<p>Date: October 18, 2021</p> <p>Item #: P21-268</p> <p>Planner: Tyler Valentine</p> <p>Phone: 733-0440 ext. 1305</p> <p>Email: tvalentine@jacksonwy.gov</p> <p>Owner CCC's Ranch Inn, LLC PO Box 844 Jackson, WY 83001</p> <p>Applicant: Northworks Architects PO Box 4027 Jackson, WY 8.001</p>	<p>REQUESTS:</p> <p>The applicant is submitting a request for a Sketch Plan for the properties located 50 S. Cache (PIDN: 22-41-16-34-2-05-006), 45 E. Pearl Avenue (PIDN: 22-41-16-34-2-05-007), and 75 E. Pearl Avenue (PIDN: 22-41-16-34-2-05-008), legally known as N 1/2 LOT 14-16, BLK. 1, CACHE-1 , LOT 12-13, S 1/2 LOTS 14-16 BLK. 1, CACHE-1 and LOT 10-11, BLK. 1, CACHE-1 respectively.</p> <p>For questions, please call Tyler Valentine at 733-0440, x1305 or email to the address shown below. Thank you.</p>
<p>Please respond by: November 2, 2021 (Sufficiency) November 9, 2021 (with Comments)</p>

CONDOS AT CACHE + PEARL

SKETCH PLAN SUBMITTAL

RESPONSES TO THE
TOWN OF JACKSON
PLANNING DEPARTMENT
PRE-APPLICATION
CONFERENCE
(30 JUNE 2021)

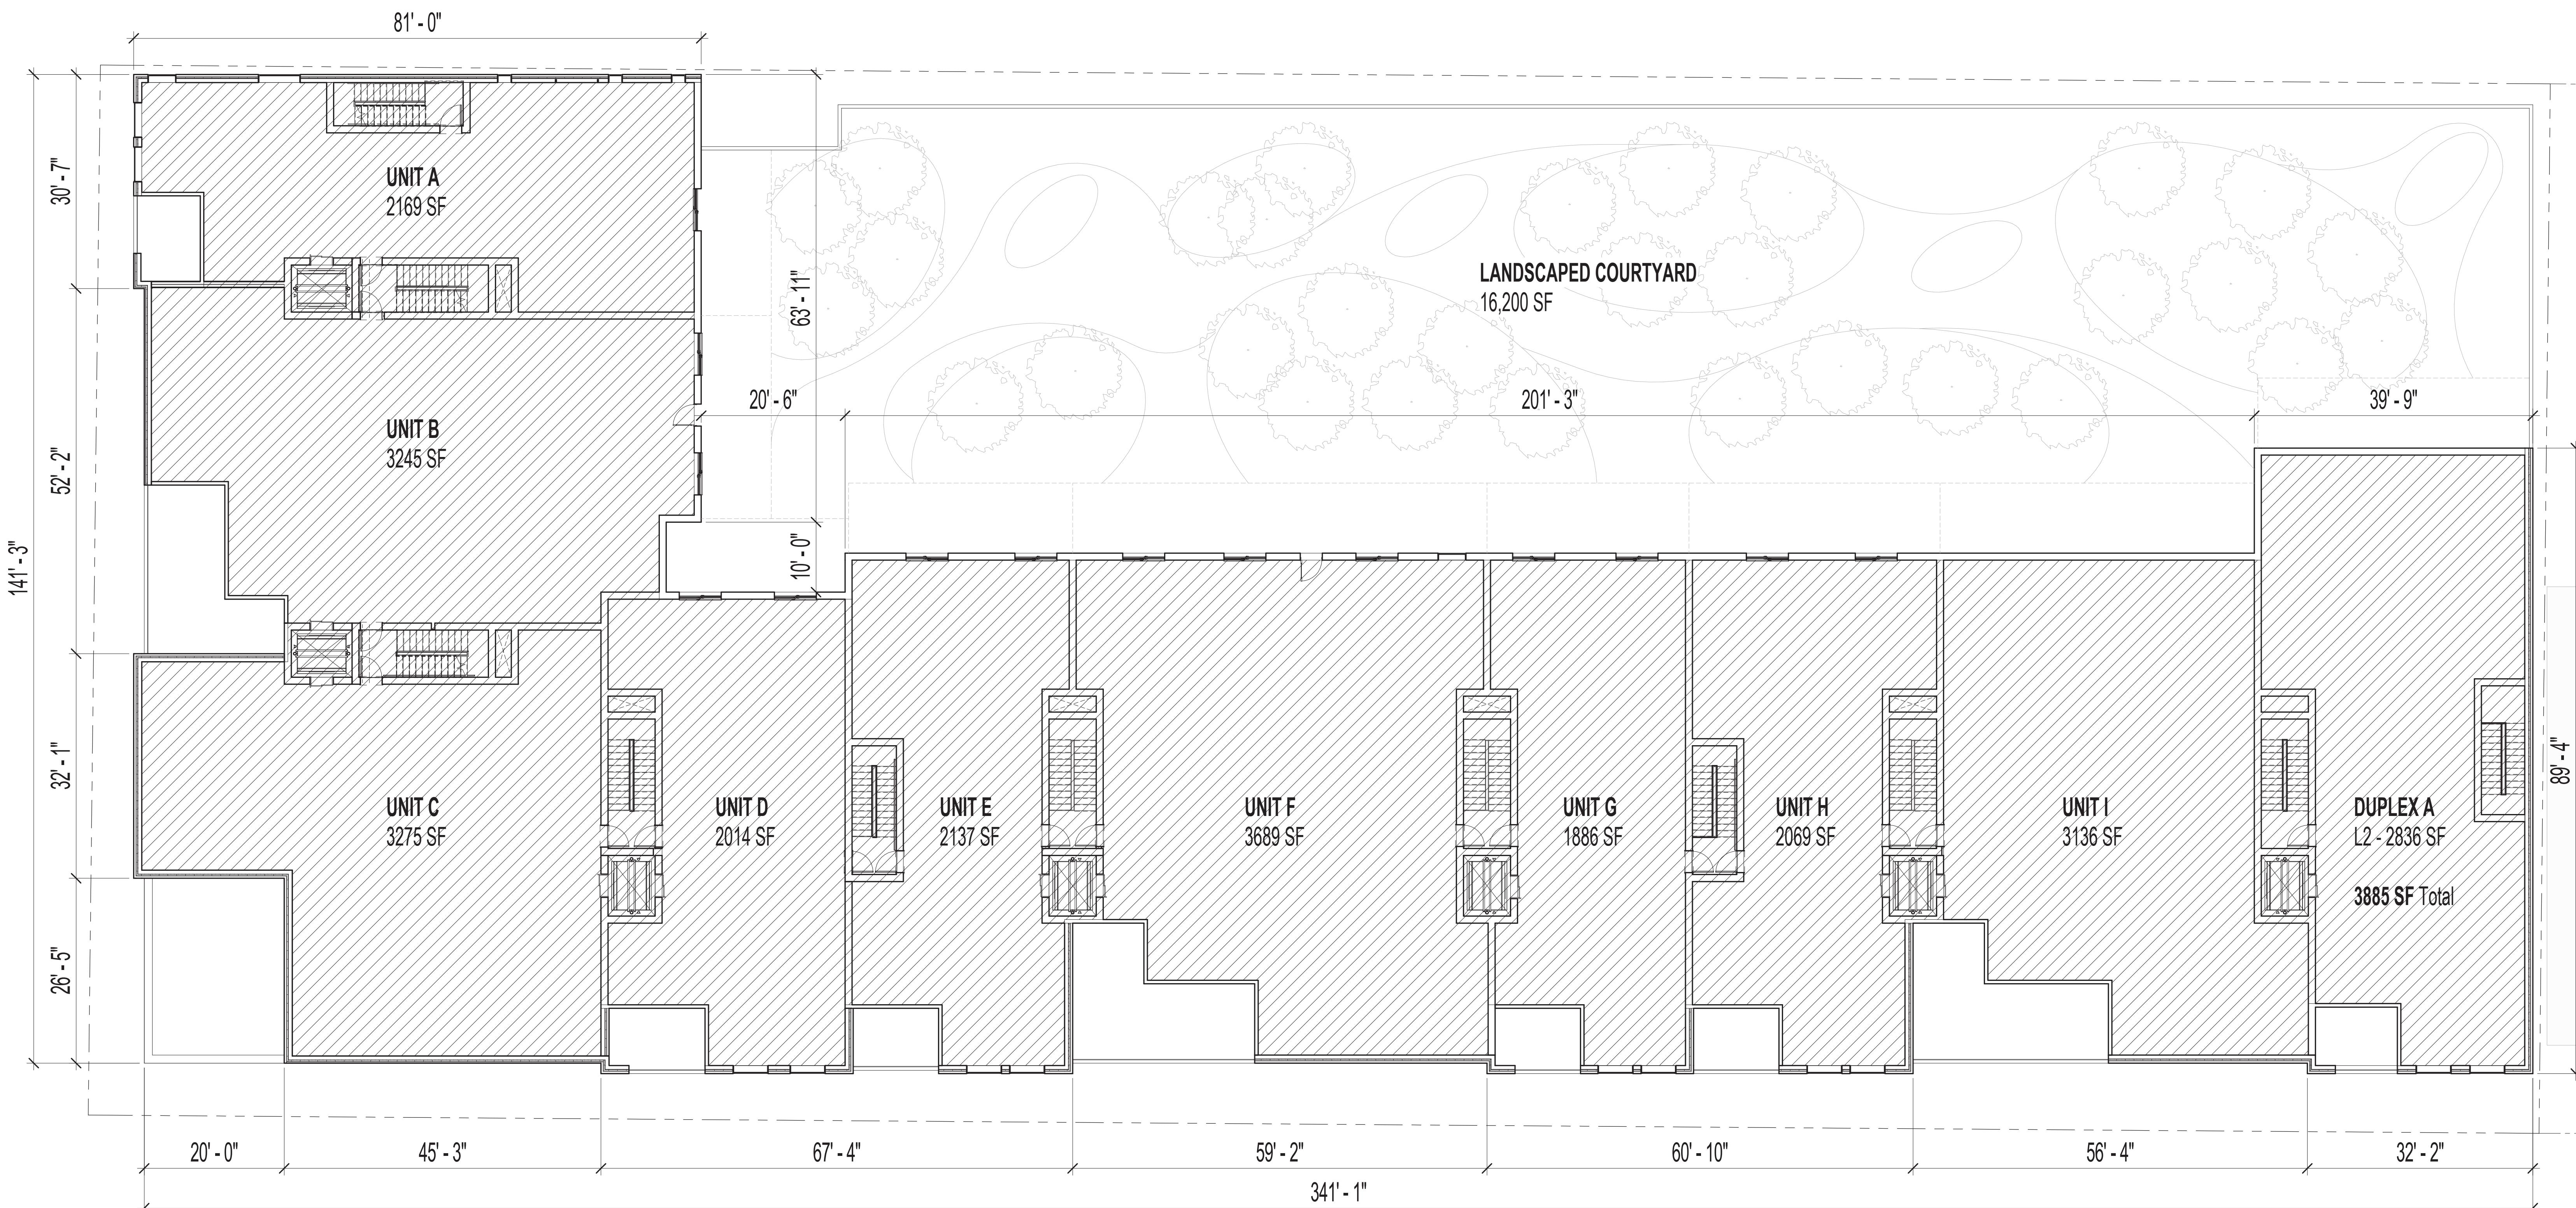
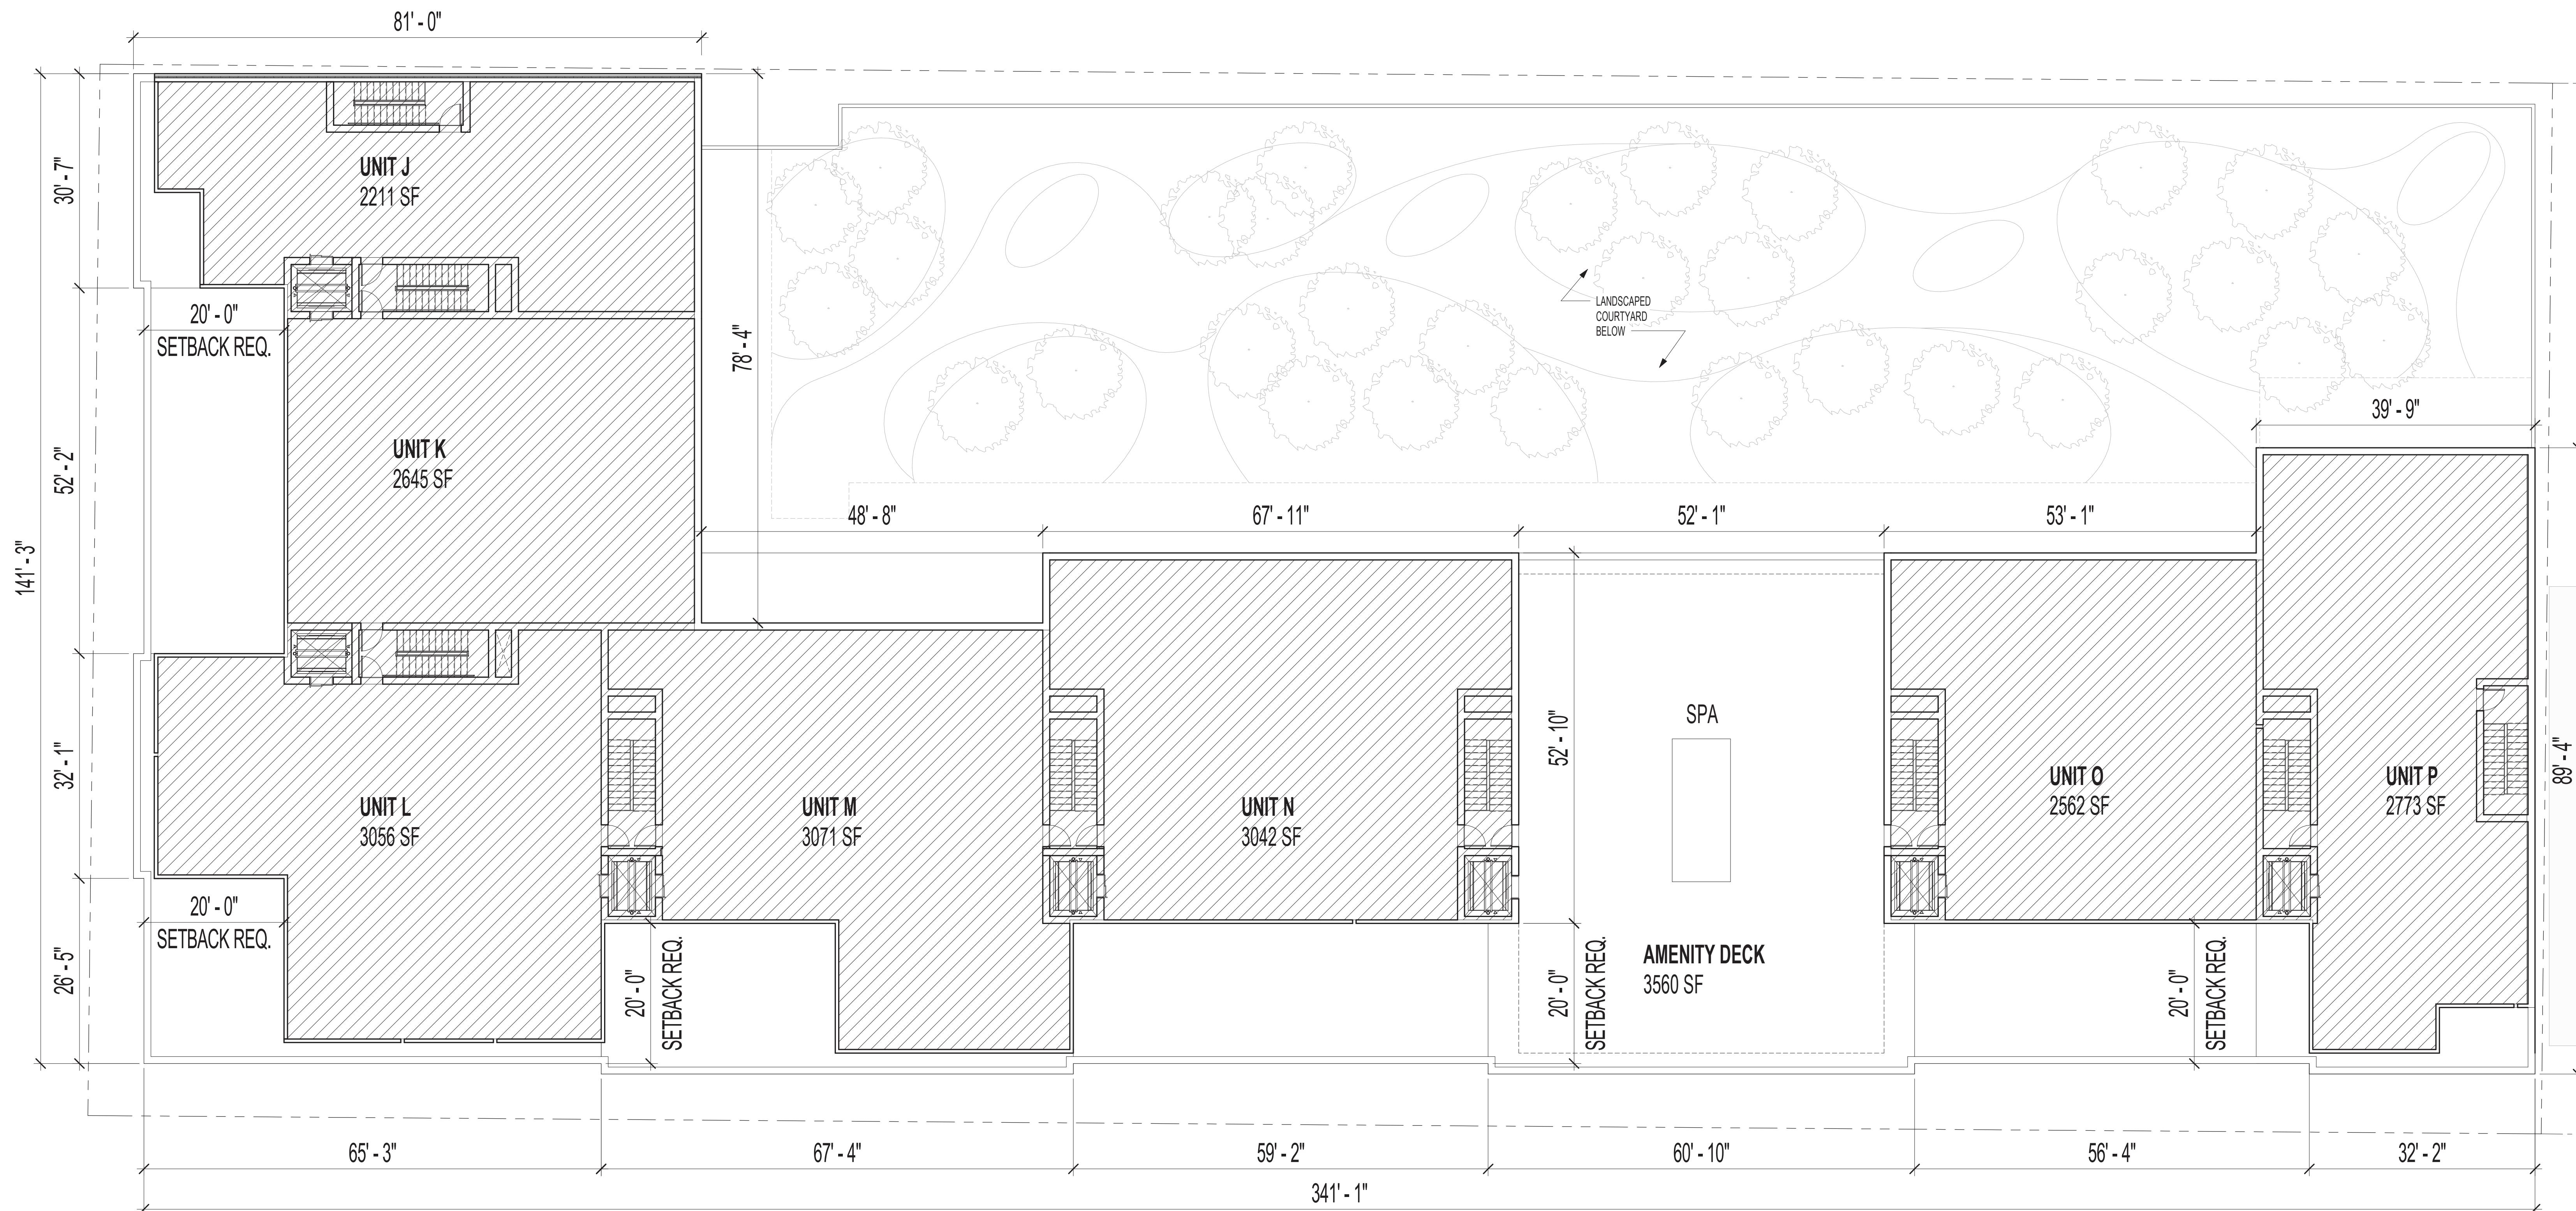
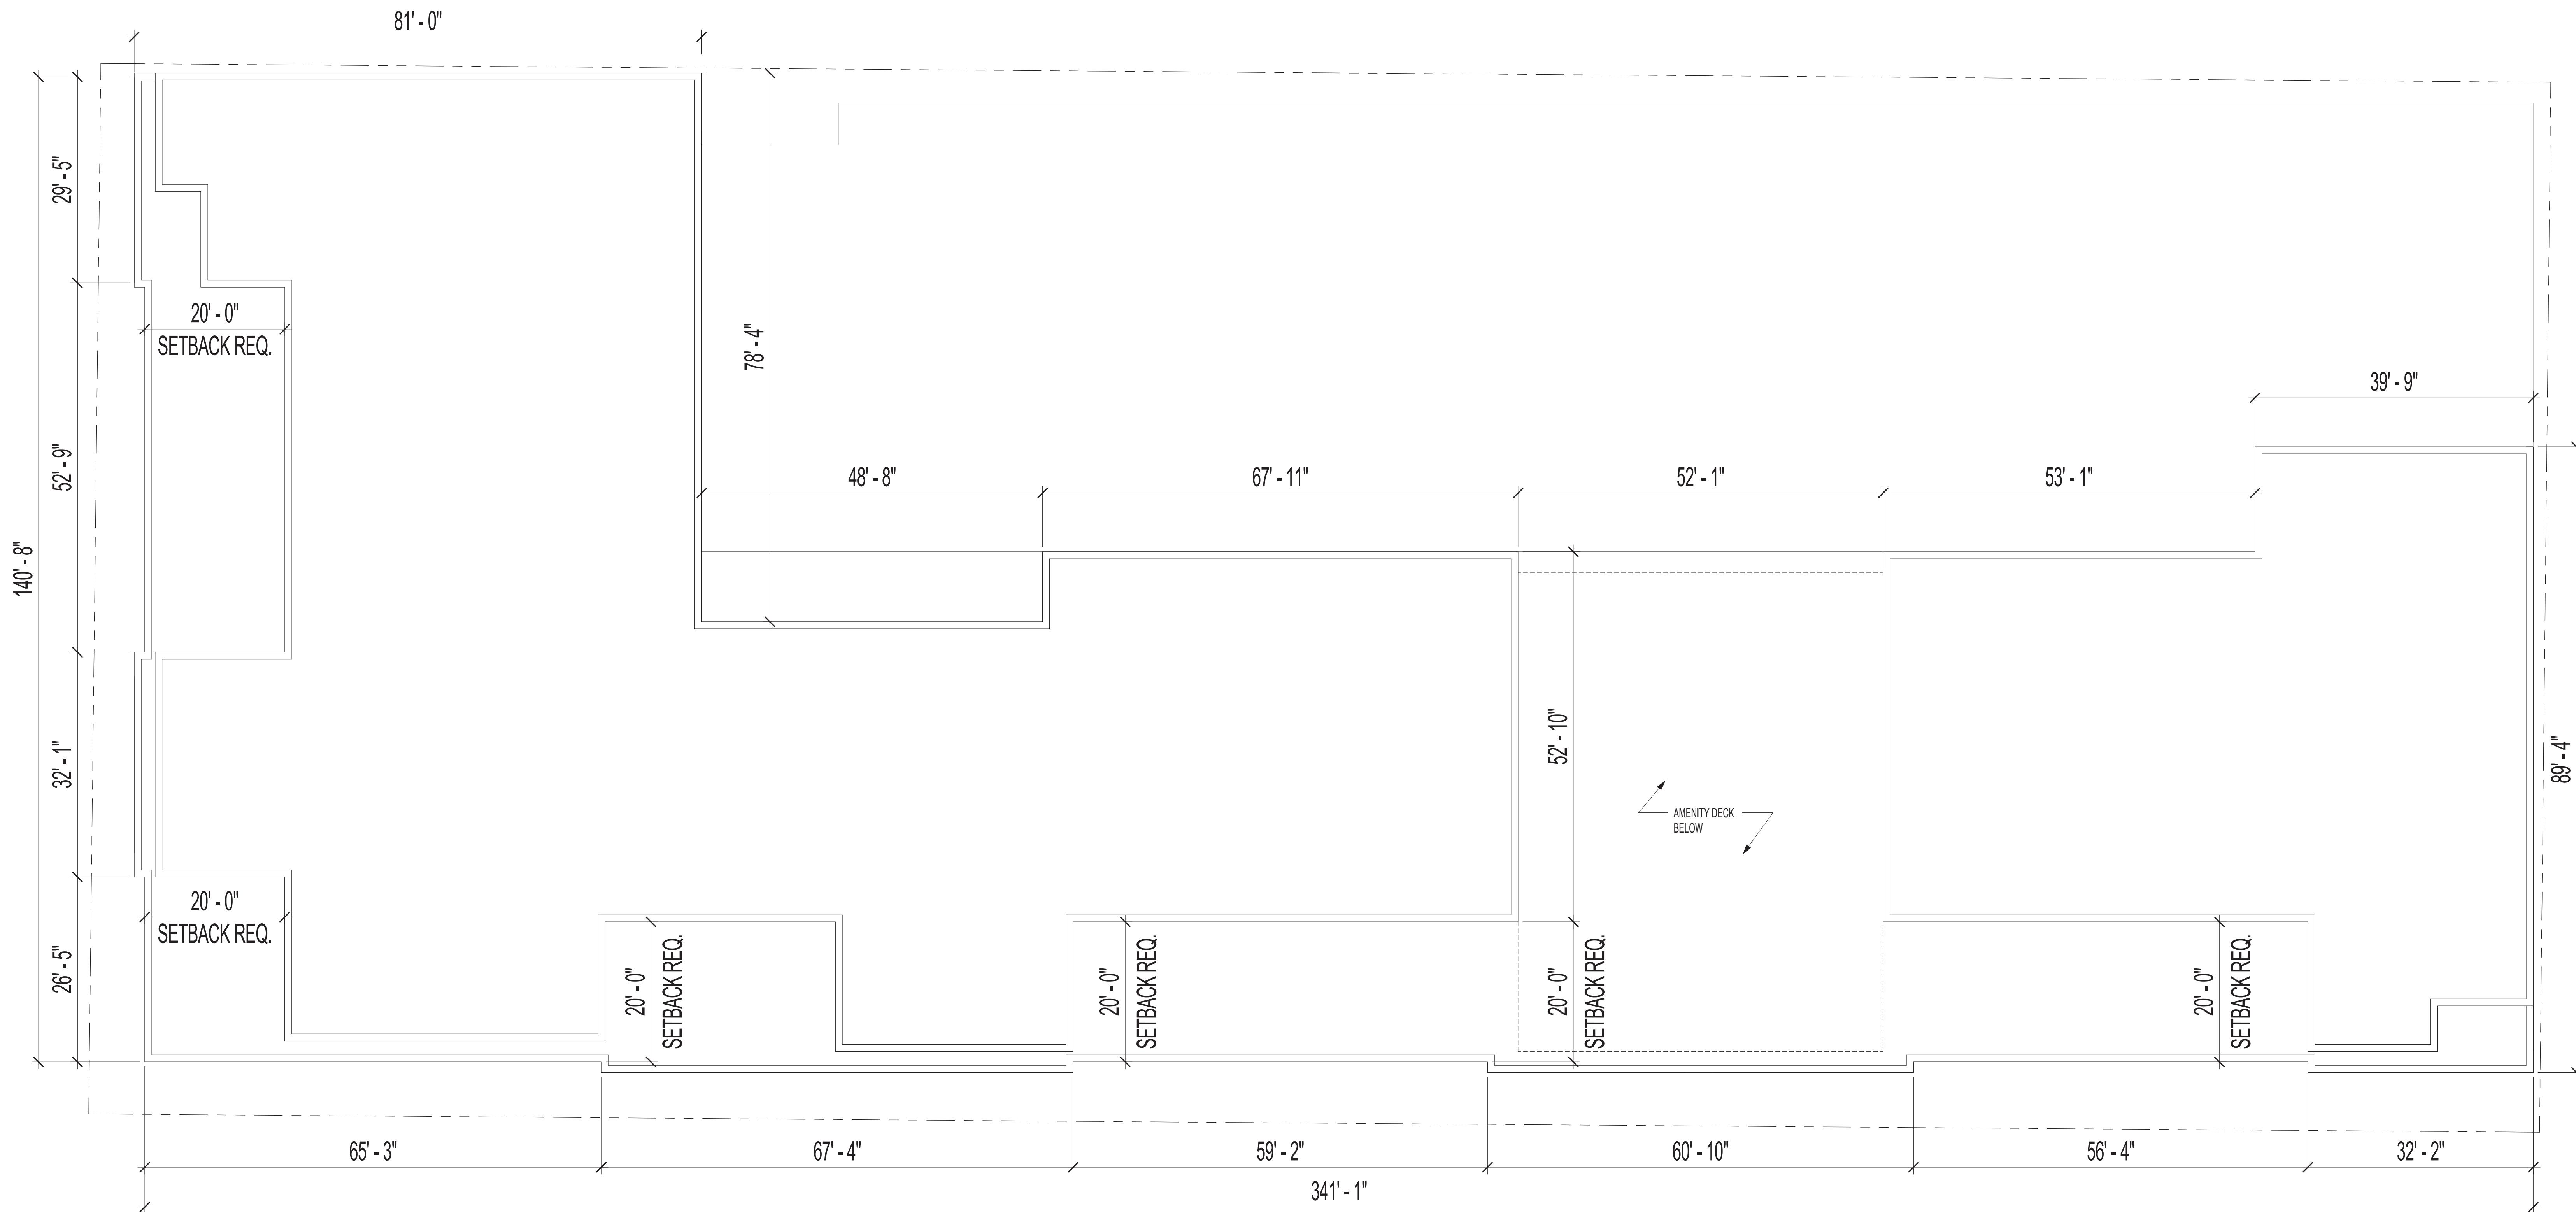
8. Uses: Is the intent to have on 8,000 sf retail space on the Cache frontage? If so, would be nice to break this into at least two smaller spaces. More variety at ground level better activates the street. If project ends including the entire Pearl frontage, the goal would be to include a number of individual commercial spaces along the street and to avoid first level condos. Outdoor dining and public amenity space should be considered in overall program if possible.

- 16 units are shown in the parking chart, yet the floor plans indicate 18 units. Please update the parking chart to reflect the correct amount of parking per unit.

Since the comment was made, the applicant has revised the ground level plans to provide a clear hierarchy between the residential lobby entrances and the retail entrances. This design was unanimously approved by the DRC on October 13, 2021. The intention of the proposed plan is to have multiple, individual, smaller commercial spaces.

17 units are currently being proposed. The parking chart is updated to reflect this quantity.
